Planning Panels Victoria

Ballarat Planning Scheme Amendment C217ball Ballarat 11 Waterways Flood Study

Panel Report

5 October 2026

Figure 3 Proposed flood control mapping at Rodney Ventures land, Canadian

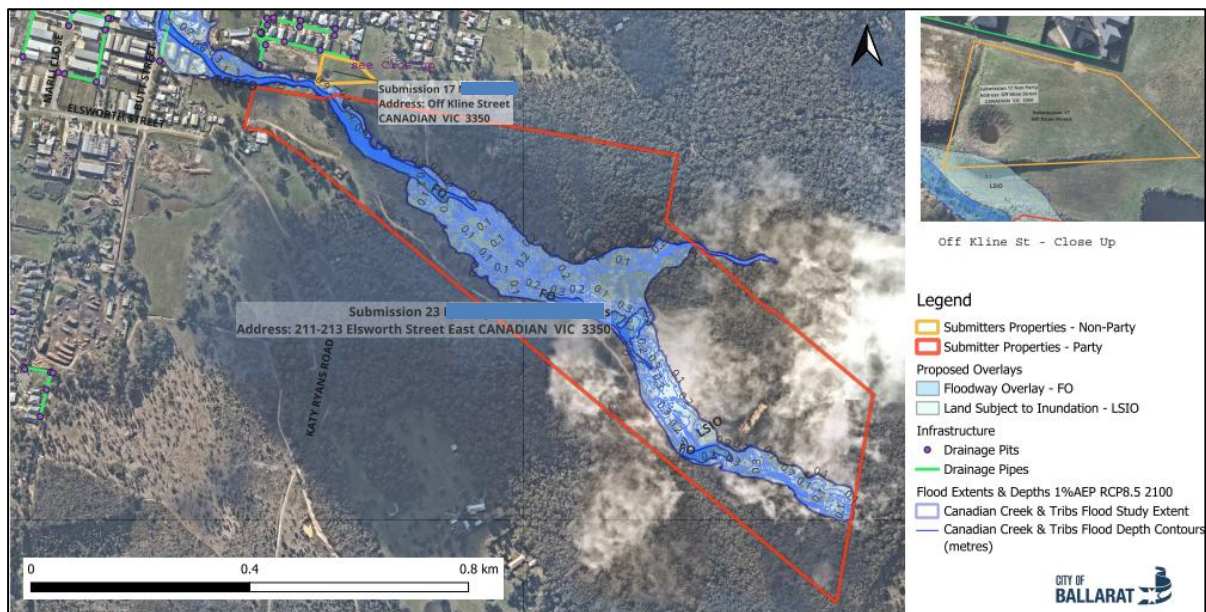
It is proposed to apply the Floodway Overlay and LSIO to part of the land at 211-213 Elsworth Street, Canadian (Rodney Ventures land).

Figure 4 Proposed flood control mapping at Integra Sites A, B and C, Alfredton

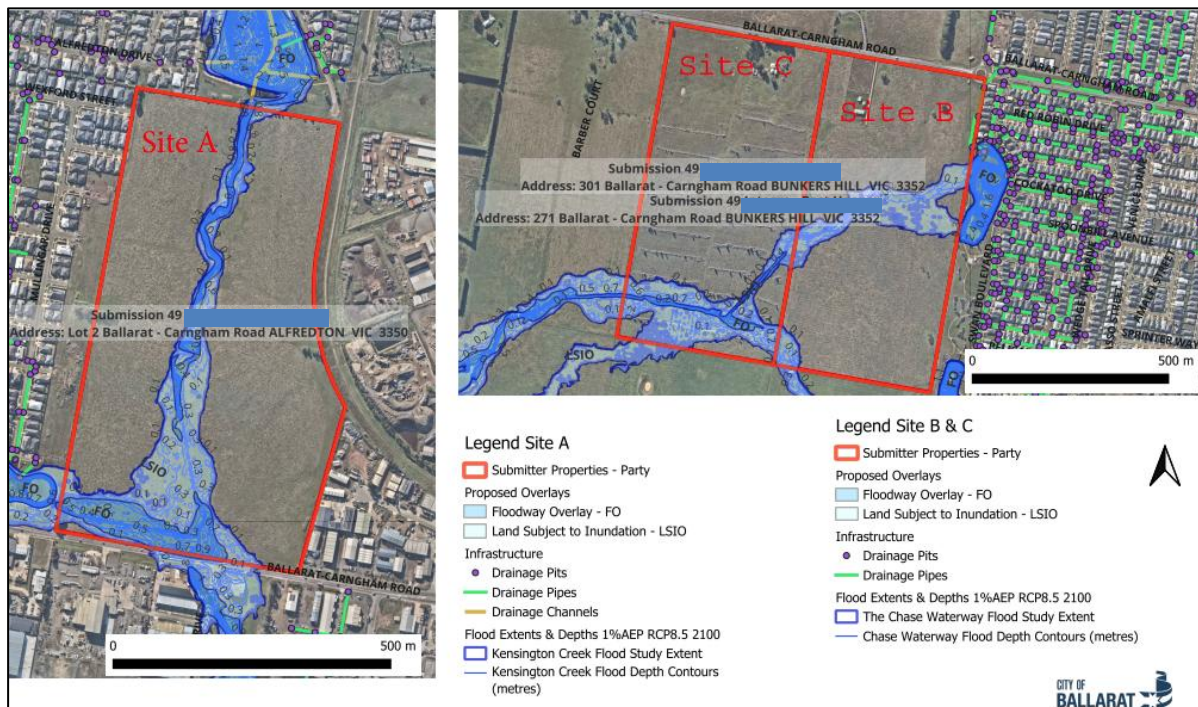
Council's Version 1 Amendment documents proposed to delete the Floodway Overlay from Integra Sites A, B and C.

- The Floodway Overlay should be replaced with the LSIO on Lot 2 Ballarat-Carngham Road, Alfredton (Integra Site A)
- Further work is required before the Floodway Overlay can be removed from the land at 271 and 301 Ballarat-Carngham Road, Alfredton (Integra Sites B and C). Specifically, the Council should:
 - should review flood control mapping against the planning principles identified at Chapter 4.1 of the report, particularly in relation to the certainty of future land use and development
 - compare or distinguish the approach on these sites to other sites in rural settings, where the Floodway Overlay has not been revisited or removed
- No change is required to the flood control mapping at Lot 1 PS928934 Ross Creek Road, Bonshaw (Bonshaw Site).

- 2. Amend the Floodway Overlay Schedule 2 mapping to remove its application from the land at:**
 - **1, 1A, Shop 1/1, Shop 2/1m Shop 3/1 and 61 Curtis Street, Ballarat (Alfred Square land).**
 - **Lot 2 Ballarat-Carngham Road, Alfredton (Integra Site A) (as shown in the Version 1 Amendment documents – Document 49).**

Figure 6 Proposed flood control mapping at 402-404 Main Road, Golden Point

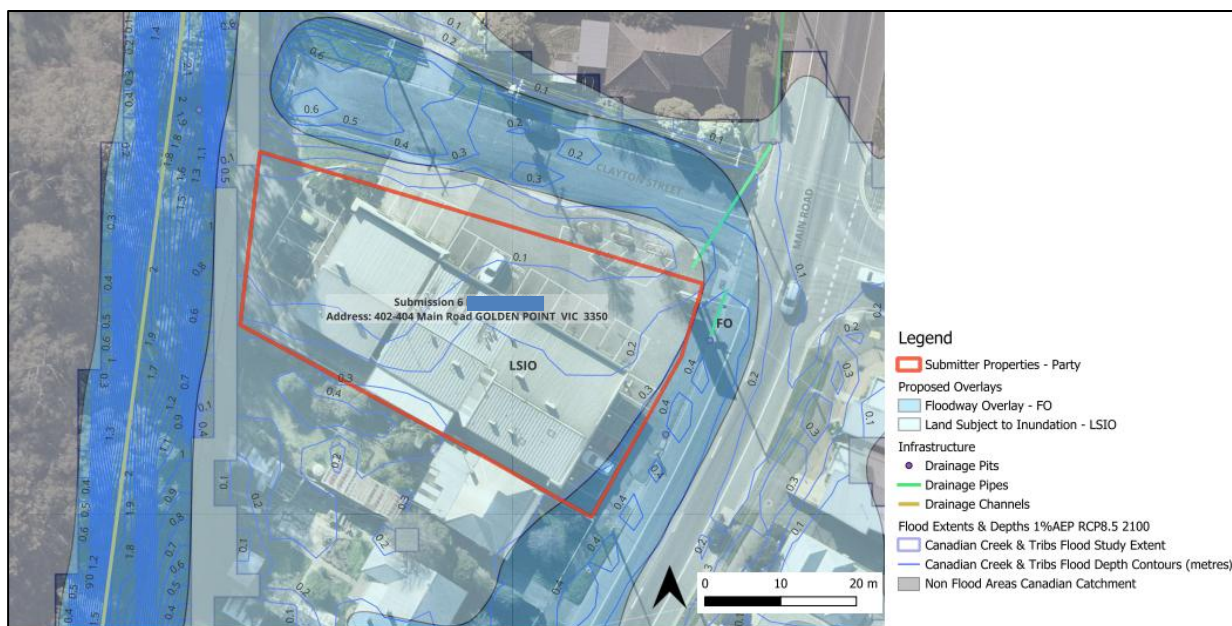
It is proposed to apply the LSIO to the whole of the land at 402-404 Main Road, Golden Point and the Floodway Overlay to part of the land.

Figure 8 Proposed LSIO mapping at 5 Deep Lead Close, Canadian

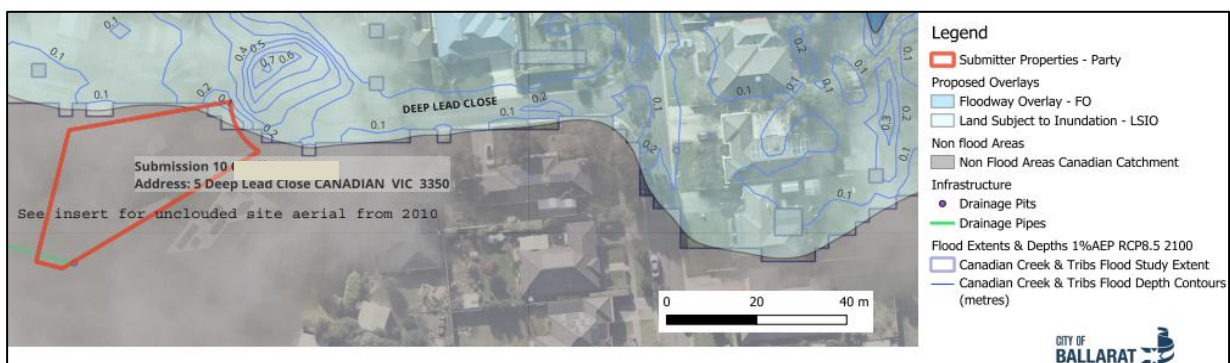
It is proposed to apply the LSIO to part of the land at 5 Deep Lead Close, Canadian.

Figure 10 Proposed flood control mapping at 425 Richards Street, Canadian

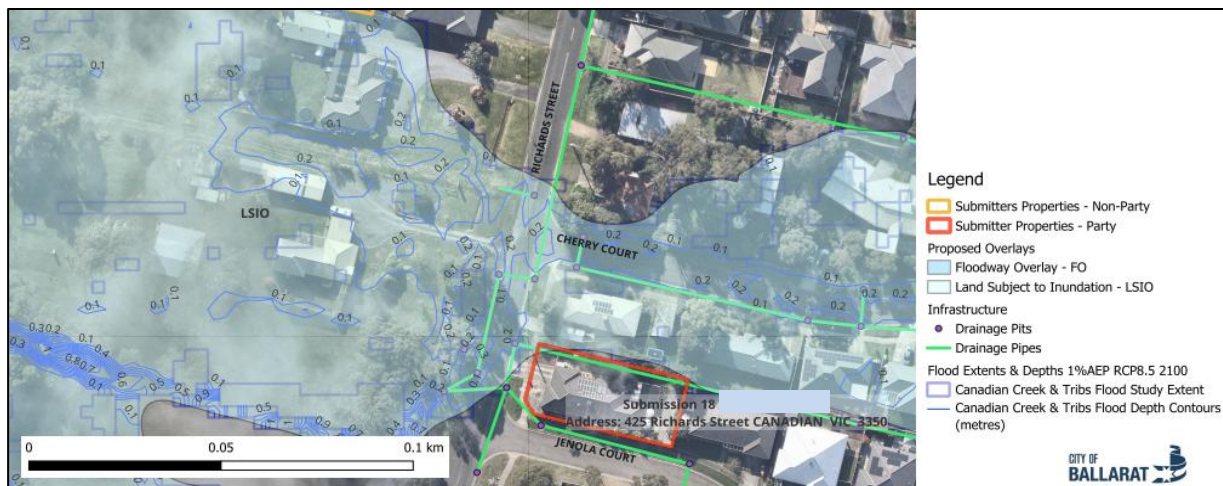
It is proposed to apply the LSIO to part of the land at 425 Richards Street, Canadian.

Figure 11 Proposed flood control mapping at 18 Canadian Springs Drive, Canadian

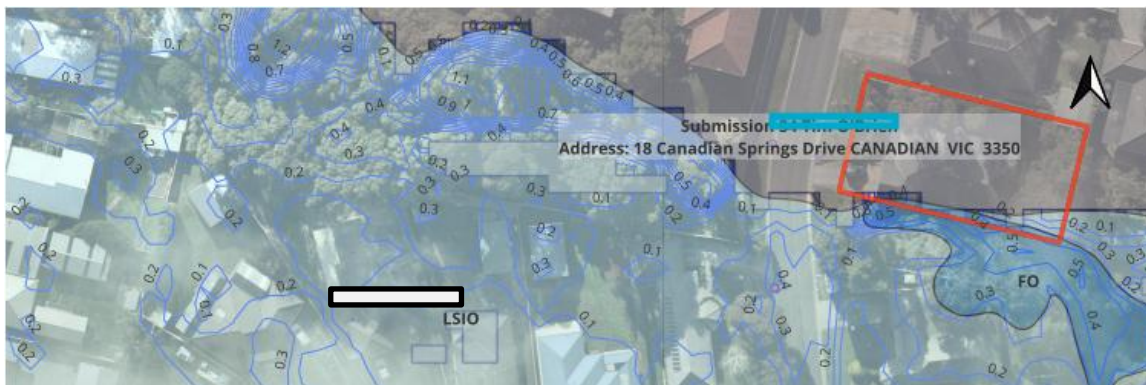
It is proposed to include part of the land at 18 Canadian Springs Drive, Canadian in the Floodway Overlay and the LSIO.

Figure 12 Proposed LSIO mapping at 13 Whitefield Street, Blackhill

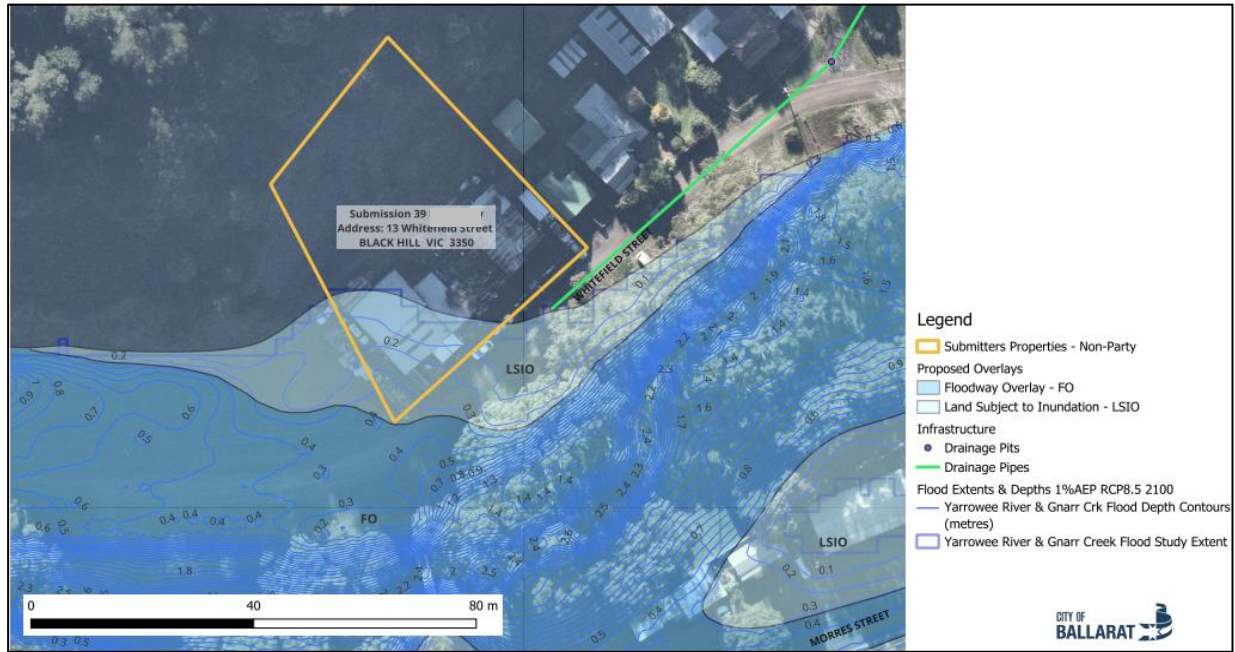
The Panel acknowledges the concerns of submitters in relation to the capacity of drainage infrastructure, particularly in locations such as Whitefield Street where there is currently no constructed road, kerb or channel. However, the flood controls need to be based on the hazard that exists today and any infrastructure that influences riverine flows. This Amendment does not replace the role of Council in infrastructure provision, maintenance or upgrade – this will continue to be addressed through separate capital works and asset management processes.

It is proposed to apply the LSIO to part of the land at 13 Whitefield Street, Blackhill.

Figure 14 Ballarat CBD as described by drainage experts

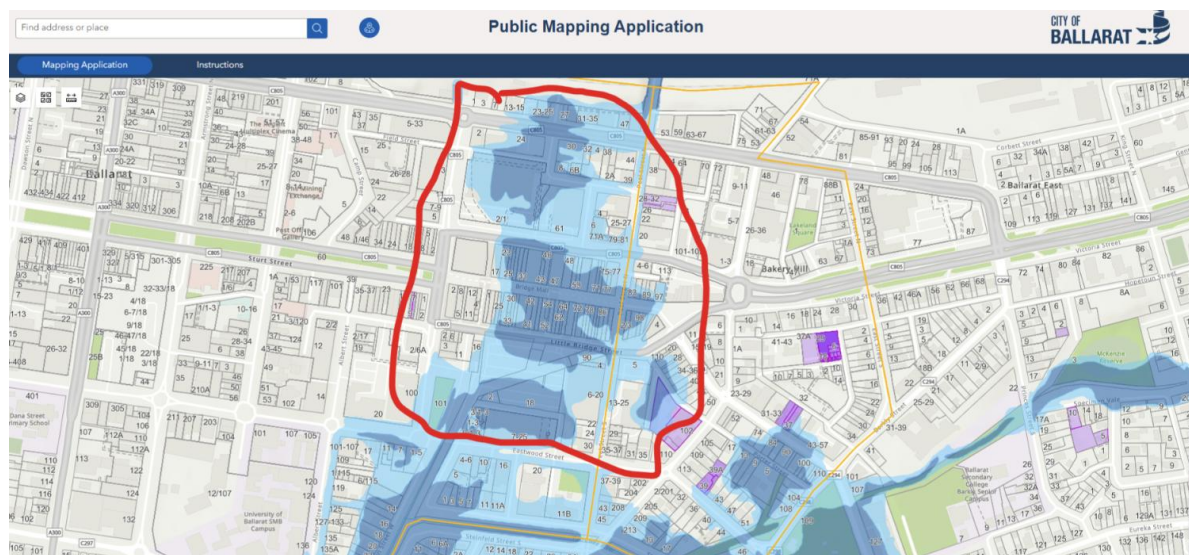
The FO in the CBD areas should be reconsidered to be a LSIO only and remove the FO. Urban centres, such as the Ballarat CBD, represent a specific scenario where greater flexibility for future development to enable flood mitigation is potentially better enabled through the LSIO schedule alone (as opposed to the FO).

During the Hearing Mr Hughes explained that the 'Ballarat CBD' meant the land between Mair Street and Eastwood Street and prepared a sketch of the area as shown in Figure 14.
